# T.E.D.S. DESIGN EXCEPTION REQUEST

RIVERVIEW ESTATES SUBDIVISION  
280 29 Road  
Grand Junction, CO

March 2, 2006

## DESIGN EXCEPTION # 8-06

# Riverview Estates & 29 Road Vicinity Map

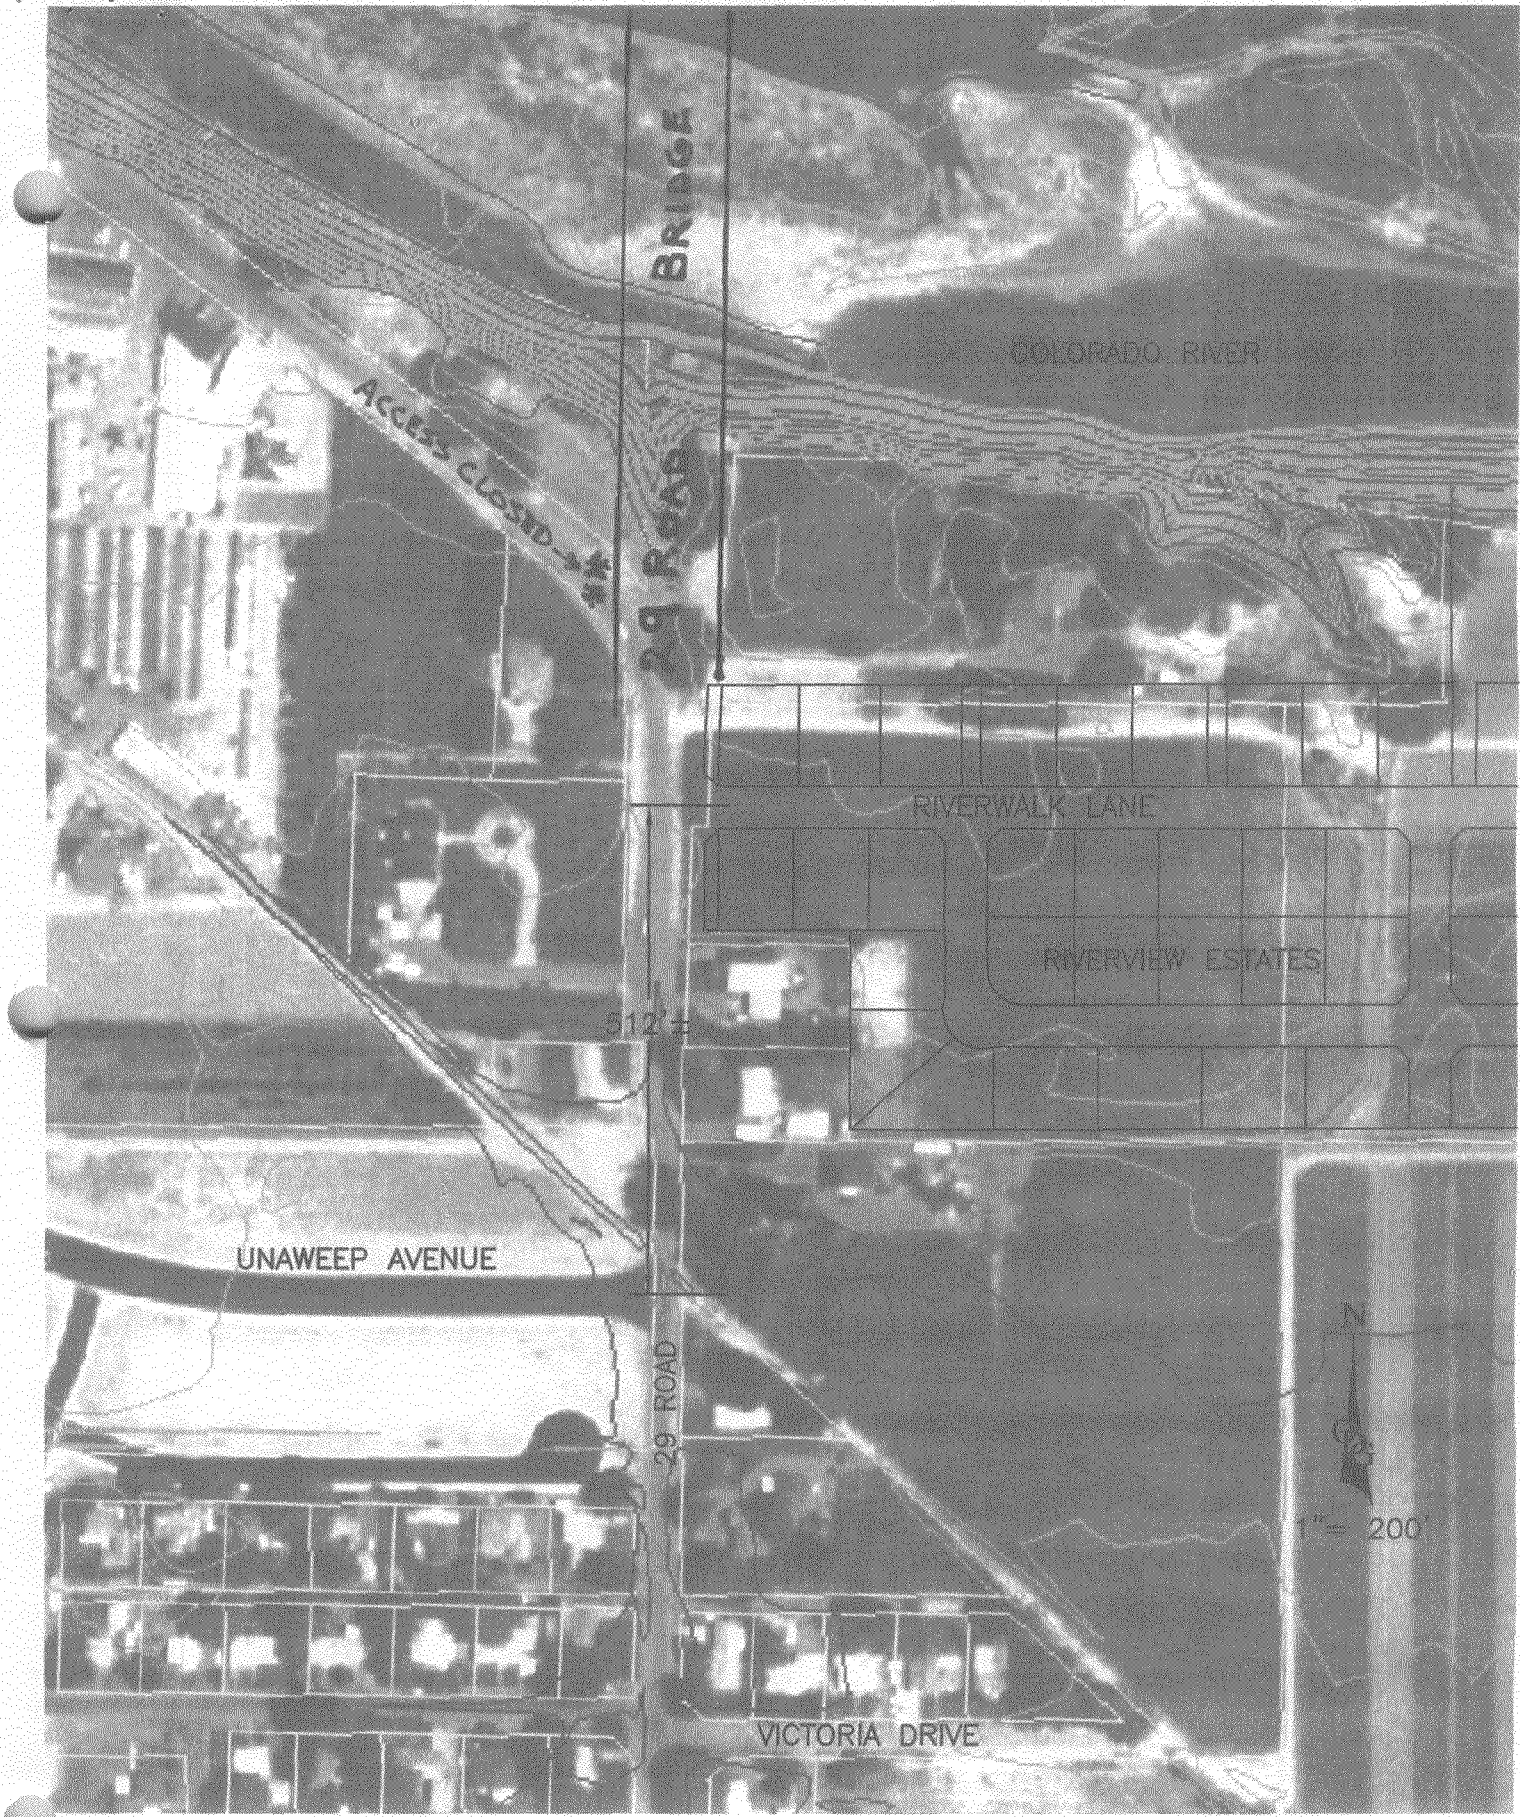
This is a request to allow installation of an access roadway (Riverwalk Lane - a proposed Urban Residential Street) creating a T-intersection with 29 Road (a designated Principal Arterial). This installation would be out of compliance with Section 6.2.8.1 of the TEDS manual given that the offset centerline spacing with existing Unaweep Avenue would be approximately 512 feet. TEDS Section 6.2.8.1 (enclosed in the appendix) indicates a desired minimum of 600 feet.

The intent of the 600 foot minimum separation on arterial streets is to provide a balance between the primarily mobility function of the street with the need for access by adjacent properties. The spacing provides for several functions, including right turn conflict overlap between entering vehicles and oncoming vehicles; the influence distance which provides adequate space for entering vehicles not to influence the speed of oncoming traffic; egress capacity; allowing for back to back left turns for access points on opposite sides of the arterial; and keeping the number of access points per mile to a minimum. Based on the topography and property ownership in this area, the 512' meets the intent of the requirement. With the Colorado River to the north, no additional access points will be allowed north of the intersection.

Staff recommends approval of this Design Exception

# RIVERVIEW ESTATES SITE DISTANCE REPORT (45 MPH)

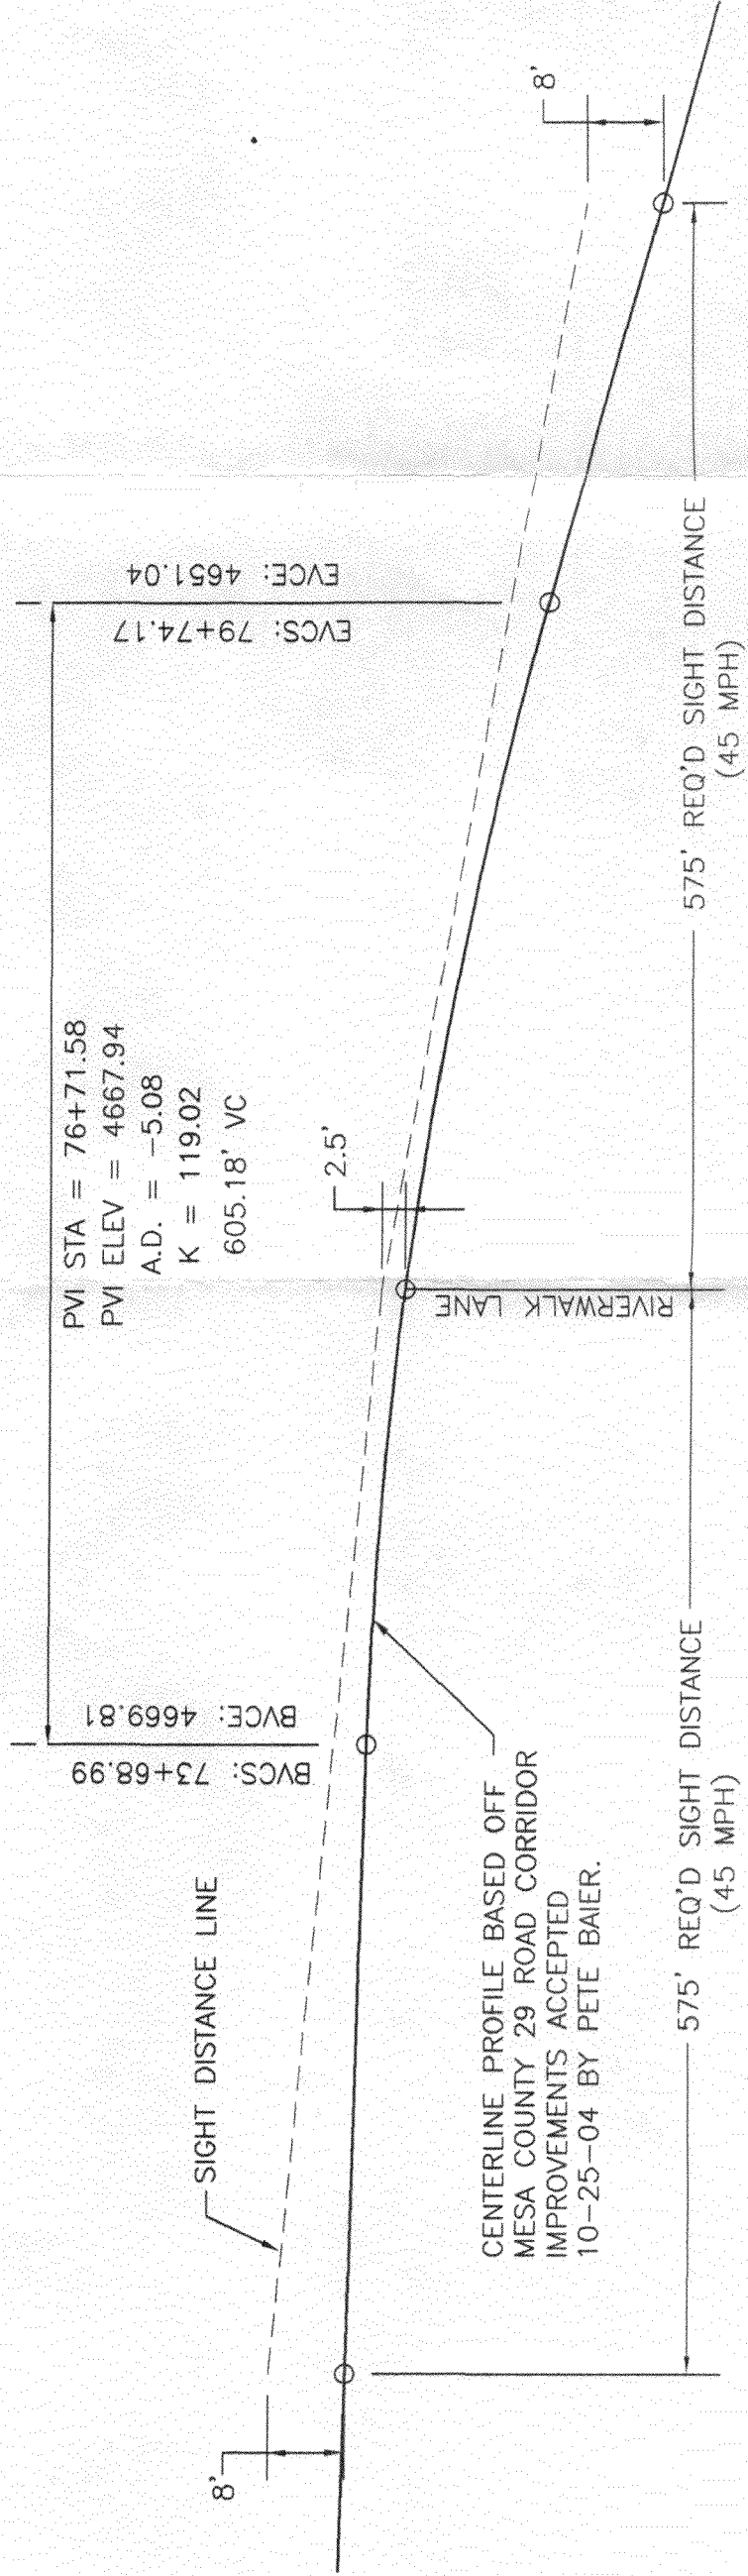
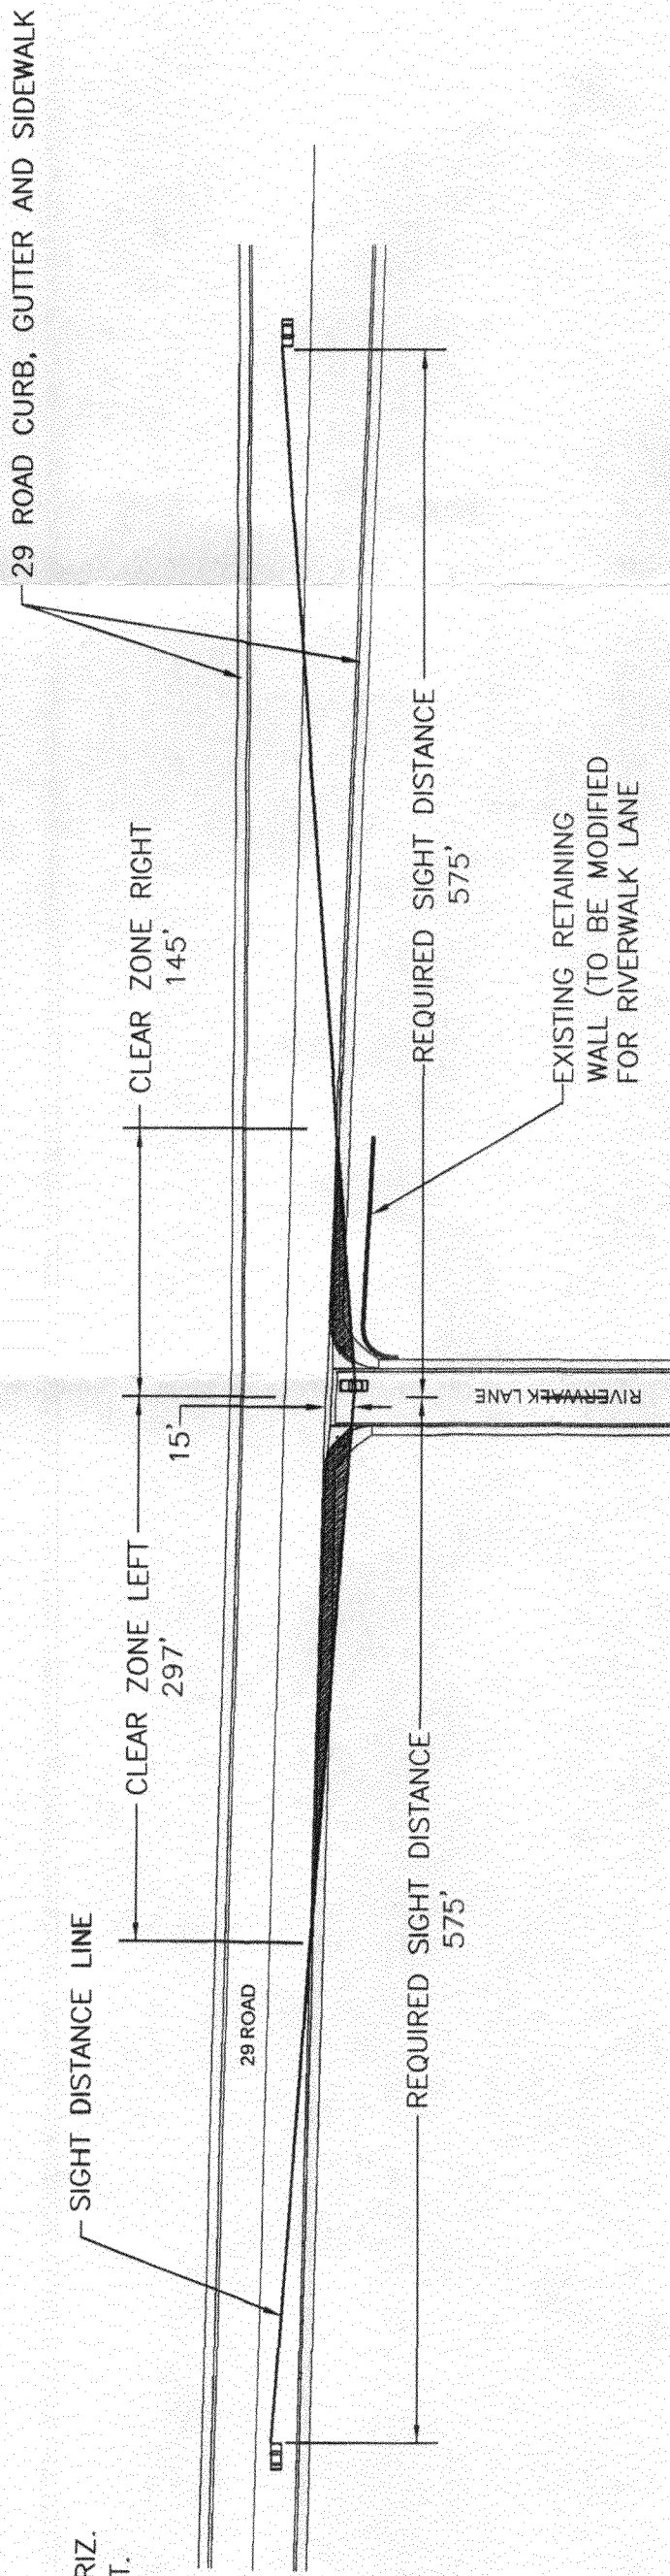
29 Road profile. Sight distance has been verified to comply with standards at the proposed location (see appendix), but may not be in compliance closer to the river, farther over the crest of the existing vertical curve in 29 Road. In addition, the existing retaining wall along the east side of 29 Road would be compromised more than the current proposal (current modification involves less than 3 vertical-feet of wall, near the existing end-of-wall). The current alignment proposal fits with an efficient double-loaded entrance road for the project, splitting the entrance parcel in two equal parts. Owners to the north, the George Decker property, have been advised that they will not be allowed to access 29 Road from their parcel in future land-use applications. They will require access through the proposed Riverview project (this access is proposed in two private drives extended to Decker - per recommendations from City engineering staff).

29 ROAD DESIGNED K VALUE = 119.02, THEREFORE STOPPING SITE DISTANCE = ±500' (55 M.P.H.)
